Product Change Notification / SYST-03MFRX853

ERRATA - dsPIC33EVXXXGM00X/10X Family Silicon Errata and Data Sheet Clarification

dsPIC33EVXXXGM00X/10X Family Silicon Errata and Data Sheet Clarification

FIGURE 1:

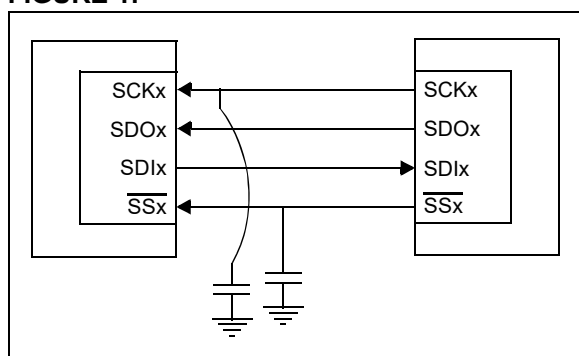
When the SPIx module is configured in SPIx Slave mode (MSTEN bit (SPIxCON1[5]) = 0), the frame slave (FRMEN bit (SPIxCON2[15]) = 1) and the SPIFSD bit (SPIxCON2[14] = 1), in Standard Buffer mode with the Clock Polarity Select bit, CKP = 0, the data are not transmitted in both 8-bit and 16-bit mode, but the data are being received correctly.

Adding a capacitance on the signal, as shown in Figure 1, will help the data to be received properly.

FIGURE 2: TIMING DIAGRAMS FOR CENTER-ALIGNED AND EDGE-ALIGNED MODES

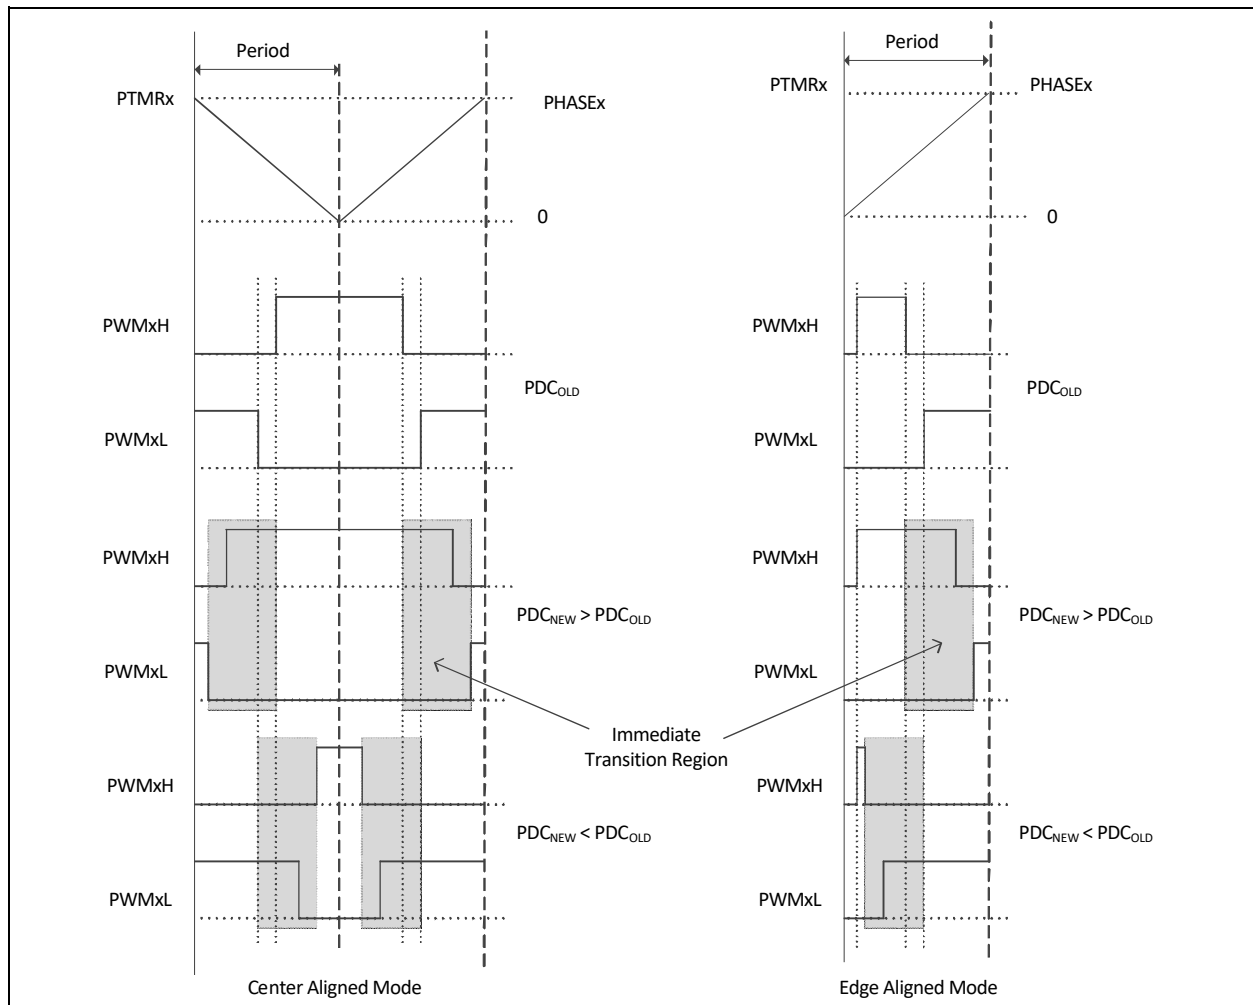
The PWM generator may not assert dead time on the edges of transitions. This has been observed when all of the following conditions are present:

In [Figure 2](#), if the duty cycle write occurred in the shaded box, then PWMxH and PWMxL will make an immediate transition without dead time.

However, in most applications, the duty cycle update timing can be controlled using the TRIGx trigger or Special Event Trigger, such that the above mentioned conditions are avoided altogether.

FIGURE 3: ILLUSTRATION OF 1 T_{OSC} GLITCH WHEN PWM OVERRIDE IS TURNED OFF

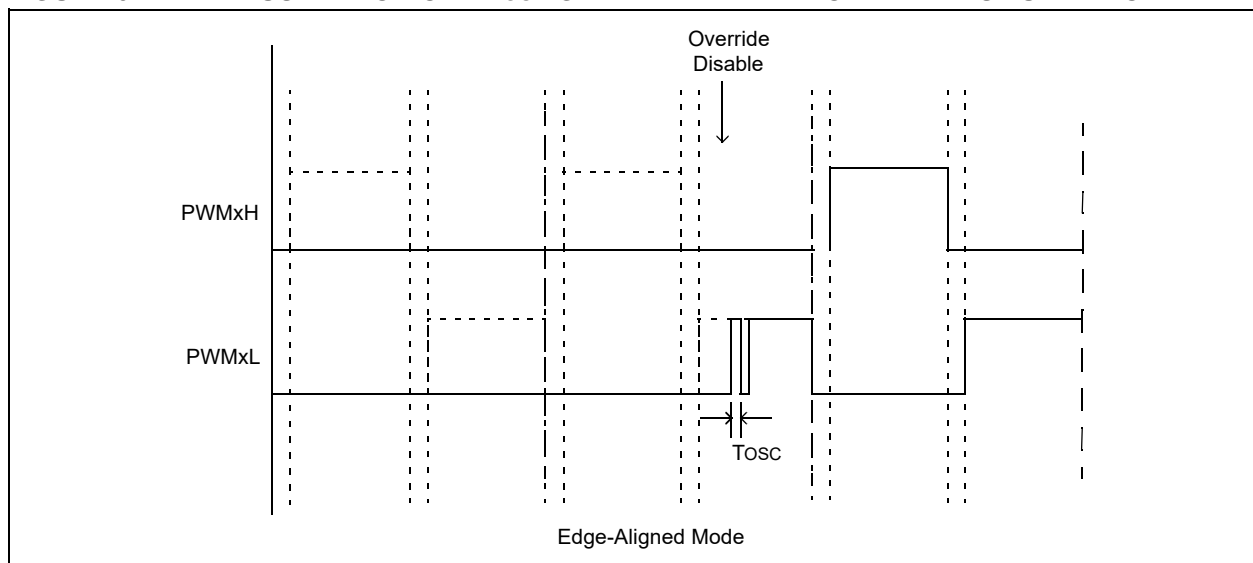
In Complementary mode after the PWM module is enabled ($PTEN = 1$), if the PWM override is turned off, a one T_{OSC} glitch will be present on the rising edge of either the PWMxH or PWMxL pins, whichever occurs first, as shown in Figure 3.

The glitch will be present on PWMxH/PWMxL every time the override state is changed from override enabled to override disabled. The width of this glitch is equal to one T_{OSC} when $PCLKDIV[2:0]$ ($PTCON2[2:0]$) = 000. Increasing the PWMx input clock prescaler setting will increase the width of the glitch accordingly.

FIGURE 4:

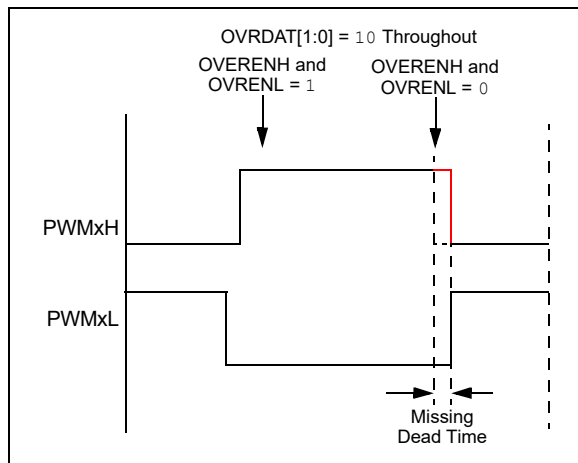
In Complementary Output mode, the expected dead time between transitions of the PWMxH and PWMxL outputs may not be asserted when the following occurs:

- Output override synchronization is configured to occur on the CPU clock boundary (IOCONx[0] = 0);
- Both PWMxH and PWMxL overrides are enabled prior to the event (OVRENH and OVRENL are both '1'), and
- Both overrides are disabled (OVRENH and OVRENL are both '0') at the instant the dead time should be asserted (Figure 4). This has been observed in both Center-Aligned and Edge-Aligned modes.

FIGURE 5:

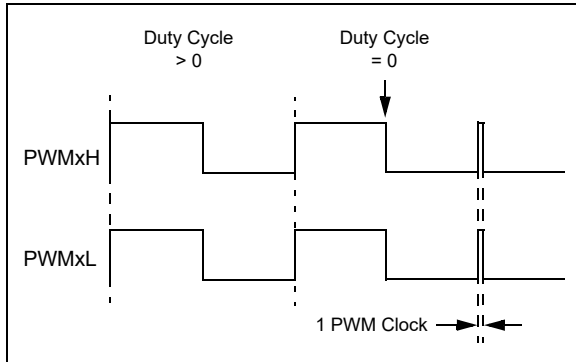
In the Redundant Output mode (IOCONx[11:10] = 10) and Push-Pull Output mode (IOCONx[11:10] = 01) with Immediate Update disabled (PWMCONx[0] = 0), when the Duty Cycle register is updated from a non-zero value to zero, a glitch pulse of a width equal to one PWM clock will appear at the next PWM period boundary, as shown in Figure 5, for the Redundant Output mode. Here, the Duty Cycle register refers to the PDCx register if PWMCONx[8] = 0 or the MDC register if PWMCONx[8] = 1.

If the application requires a zero duty cycle output, there are two possible work around methods:

1. Use the PWM override feature to override the PWM output to a low state instead of writing to the Duty Cycle register. In order to switch back to a non-zero duty cycle output, turn off the PWM override. The override-on and override-off events must be timed close to the PWM period boundary if the IOCONx register has been configured with IOCON[0] = 0 (i.e., output overrides via the OVDDAT[1:0] bits occur on the next CPU clock boundary).

2. Enable the Immediate Update (PWMCONx[0] = 1) while configuring the PWM module, i.e., before enabling the PWM module (PTCON[15] = 1). With Immediate Update enabled, writes to the Duty Cycle register can have an immediate effect on the PWM output. Hence, duty cycle write operations must be timed close to the PWM period boundary in order to avoid distortions in the PWM output.

FIGURE 6:

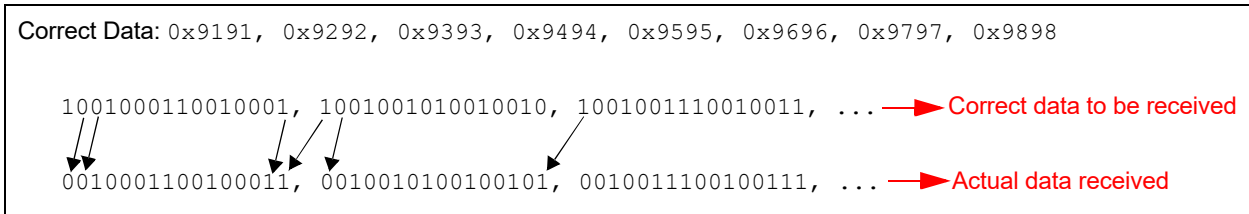
For example, the correct data that should be received are 0x9191, 0x9292, 0x9393, 0x9494, 0x9595, 0x9696, 0x9797, 0x9898, but the actual data received are 0x2323, 0x2525, 0x2727, 0x2929, 0x2B2B, 0x2D2D, 0x2F2F, 0x3130 (Figure 6).

FIGURE 7: SIMPLIFIED BEHAVIOR

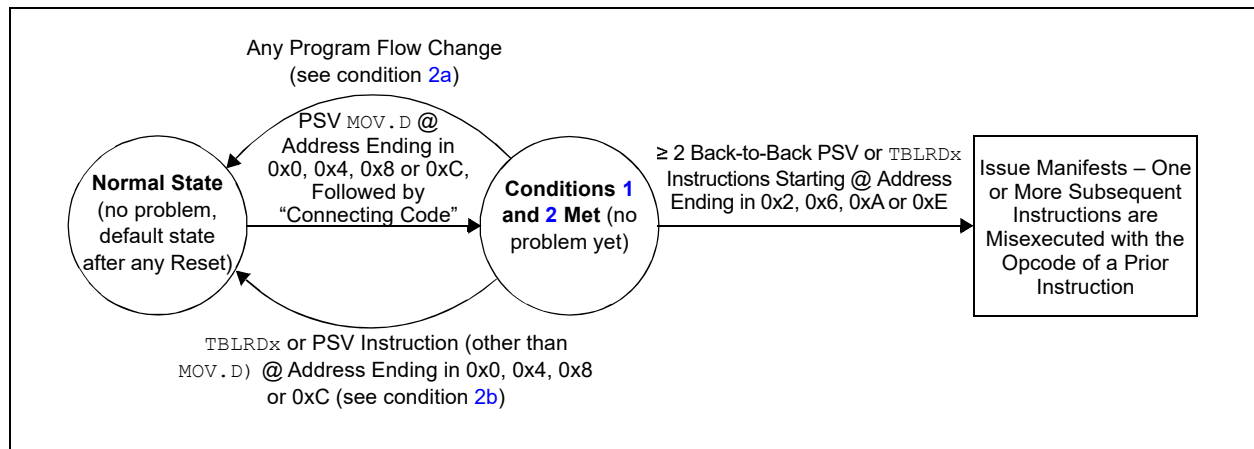
3.	≥ 2 back-to-back PSV or <code>TBLRDx</code> instructions are executed (following the code of condition 2), where the first of the back-to-back instructions is located at an address ending in 0x2, 0x6, 0xA or 0xE.

[Figure 7](#) provides an example of the effective behavior.

1. All instances of PSV MOV.D can be replaced with two PSV MOV instructions instead. Non-PSV MOV.D instructions acting on RAM/SFRs do not need to be modified; or
2. If not already present, a program flow change instruction (such as BRA \$+2) can be inserted above back-to-back data Flash read sequences; or
3. Back-to-back data Flash read instruction sequences can be broken up by inserting a non-Flash read instruction (such as a NOP), in between the Flash read instructions; or
4. The alignment of the code can be shifted to avoid the required opcode location addresses.

C code built with MPLAB® XC16 Compiler Version 1.32, or later, implements the work around by default. However, if the application uses Assembly language routines, these should be manually modified to implement the work around. Additionally, if precompiled libraries are used, these should be built with XC16 Version 1.32 or later. For additional information, please visit: www.microchip.com/erratum_psrds_psrds
